**REGULAR MEETING OF THE THIRD LAGUNA HILLS MUTUAL
ARCHITECTURAL CONTROL AND STANDARDS COMMITTEE**

**Monday, June 25, 2018 – 9:30 a.m.
Laguna Woods Village Community Center Sycamore Room
24351 El Toro Road**

DATE: June 25, 2018
FOR: Architectural Control and Standards Committee
SUBJECT: Variance Request
Ms. Yu-Hsiung Chen of 3142-A (Las Flores, PL203C, 42)
Room Addition on Back Patio

DATE: June 25, 2018
FOR: Architectural Control and Standards Committee
SUBJECT: Variance Request - Mr. Michael Epstein of 3235-C (La Reina, SB703R_B, 43R) Replace Enclosed Patio with Room Addition

Proposed Bedroom Floorplan

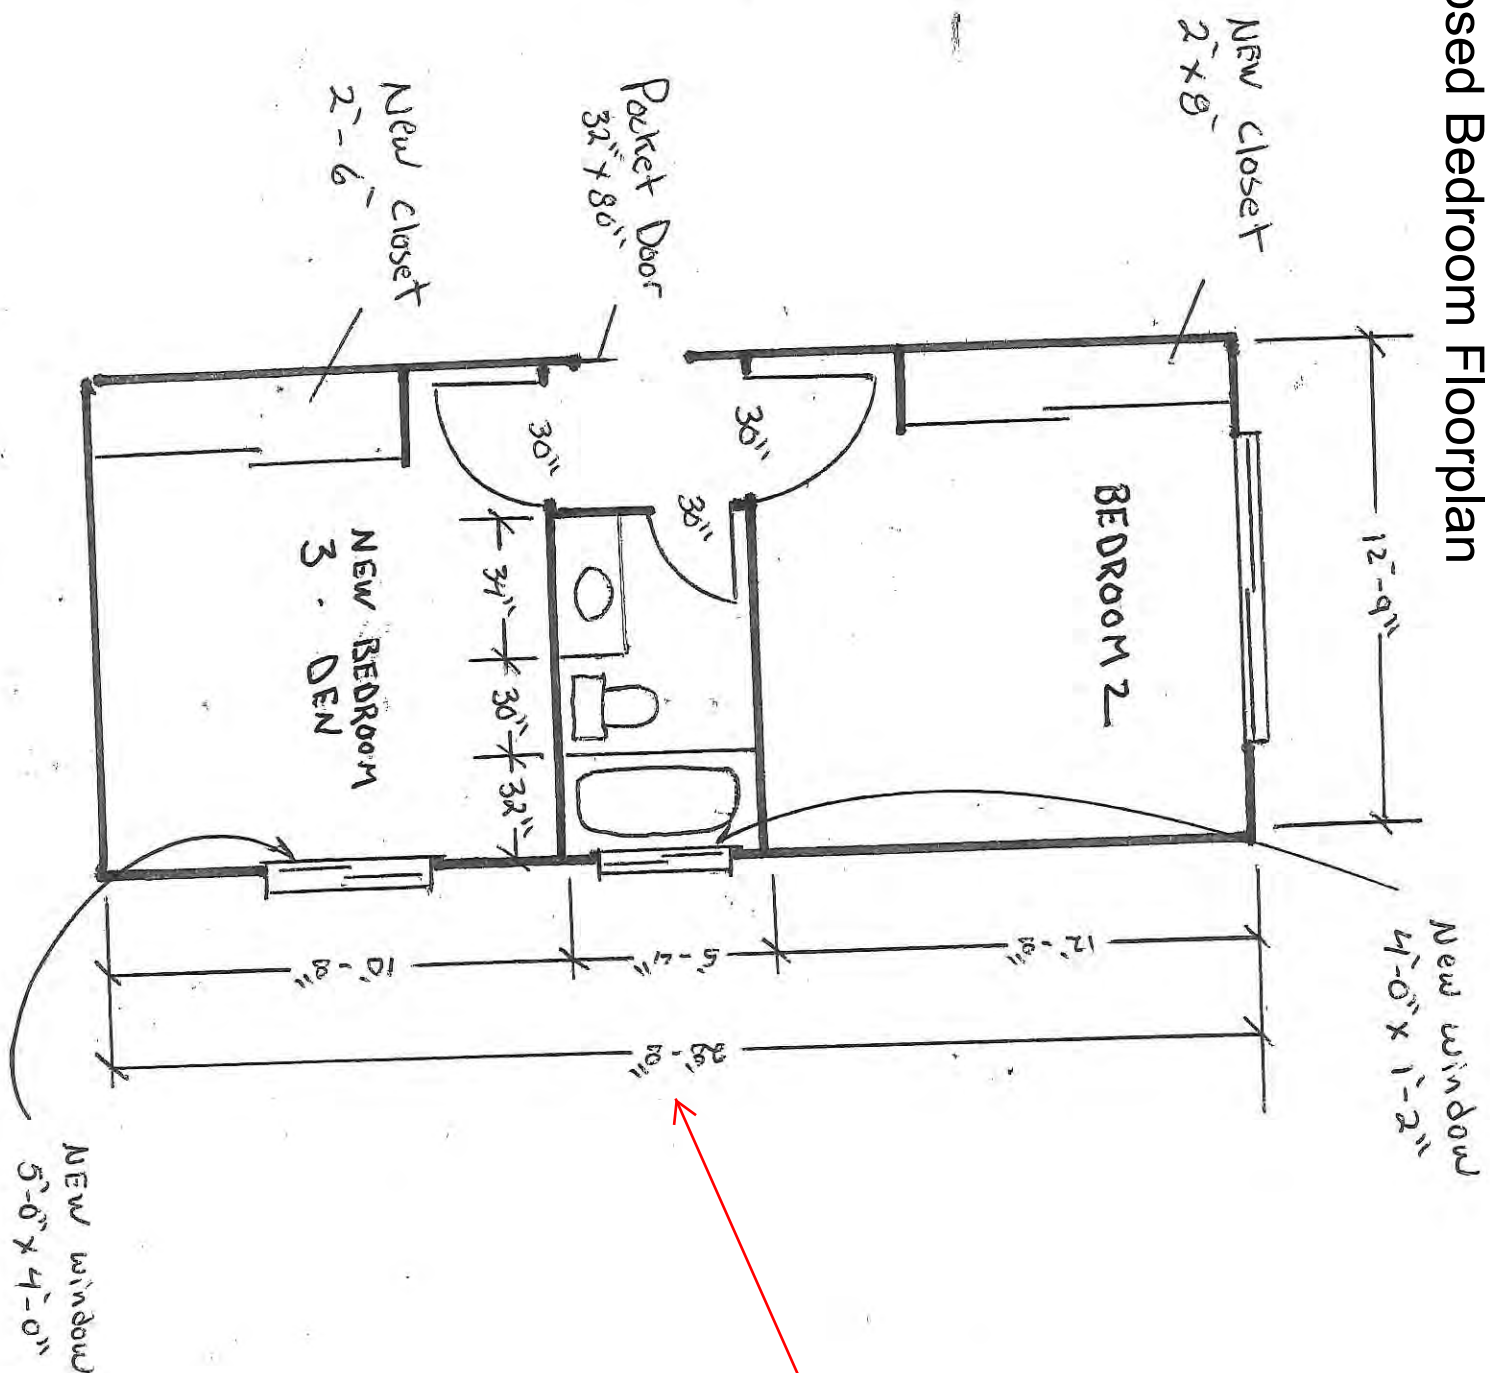
(3) Reapportion Space in Second Bedroom to Create a Third Bedroom: Ms. Chen requests to remove the existing second bathroom and closet space to relocate the bathroom towards the rear of the unit and construct a new “jack and jill” style bathroom that measures 8’ wide by 5’4” long. By adding a door along each of the new bathroom walls, Ms. Chen would create two bedrooms; one, 12’8” in length and the other, 10’8”. Both would be the original 12’ 9” in width. The new bedrooms are proposed to have new sliding door closets installed on the common wall shared with the living room.

Existing Right Side Elevation

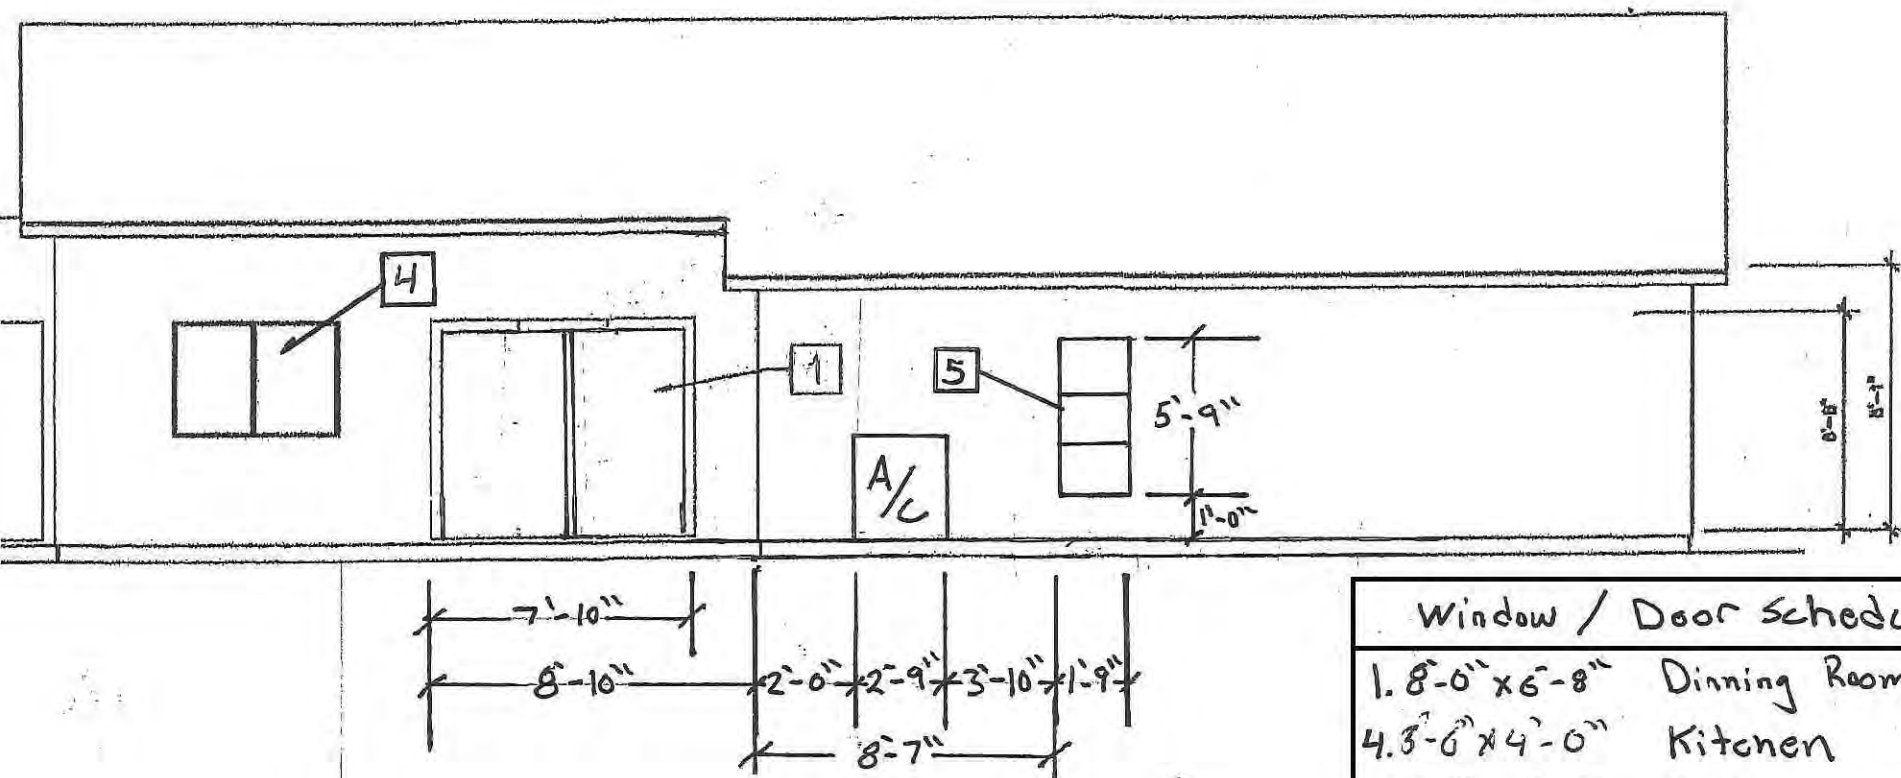
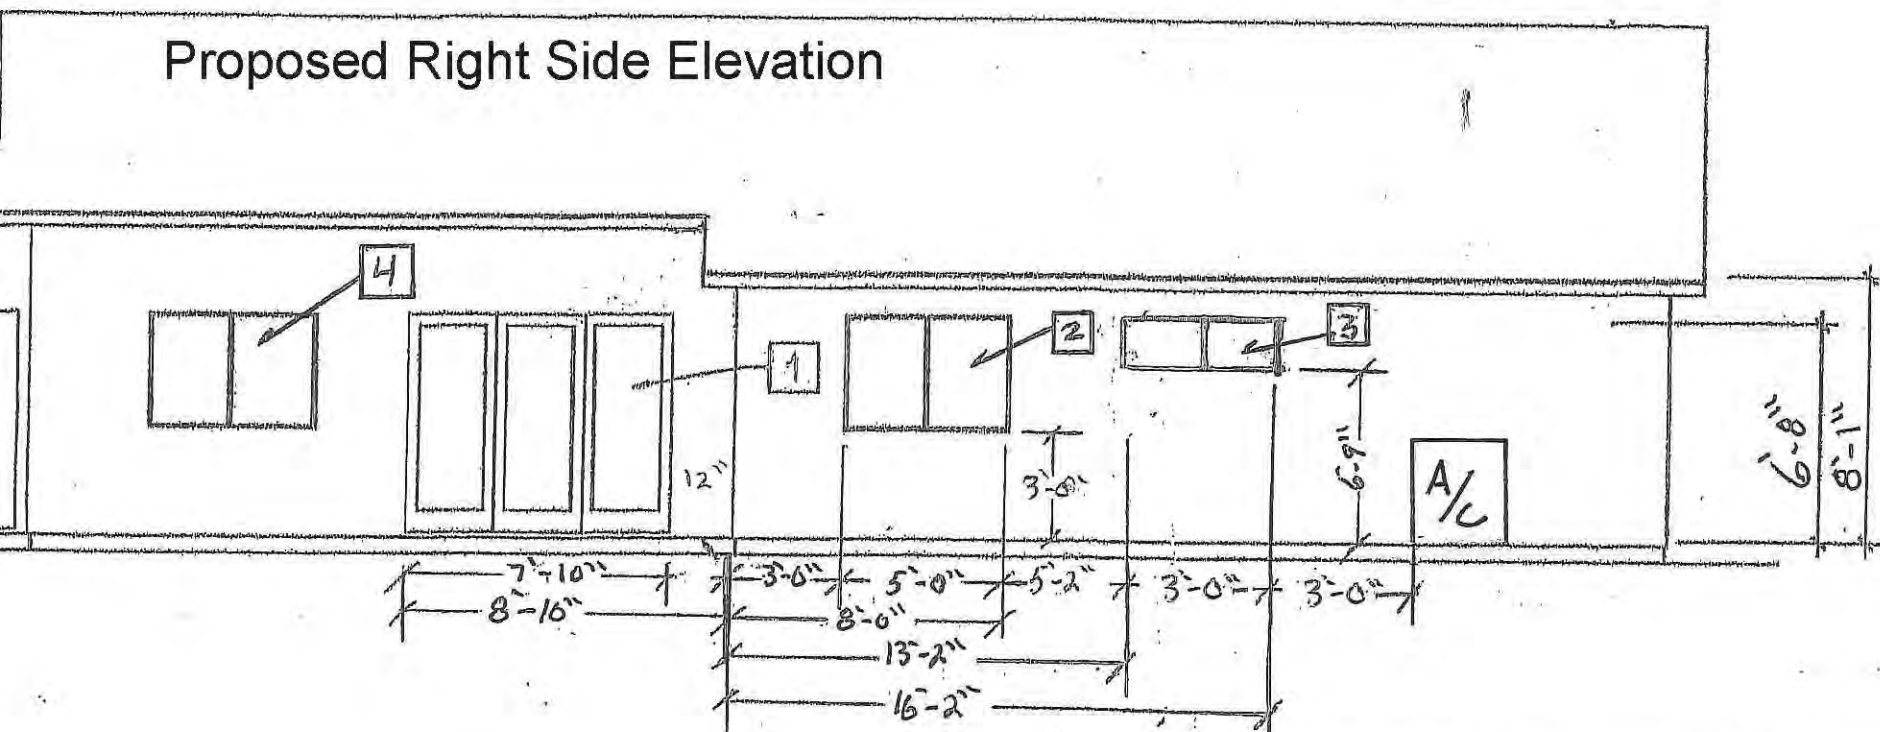
(6) Add Window in Garage: Finally, Ms. Chen requests to add a 4’ wide by 4’ window in the garage/laundry. The window would be along the same wall as the nook window. Staff recommends approval as this window is also restricted from view due to facing the courtyard. The window will be of white vinyl in accordance to Mutual Standard Section 34: Windows & Window Attachments for consistency. As part of the room addition with bedroom window being added, the air conditioner condenser will be relocated towards the rear of the unit approx. three feet away from the new bathroom window. This alteration can be processed as an over-the-counter Mutual Consent. Staff was unable to find any previous examples of a variance for Trinidad floor plans on file. This window addition may be issued as an over-the-counter Mutual Consent, but is listed here to give the Committee the full project.
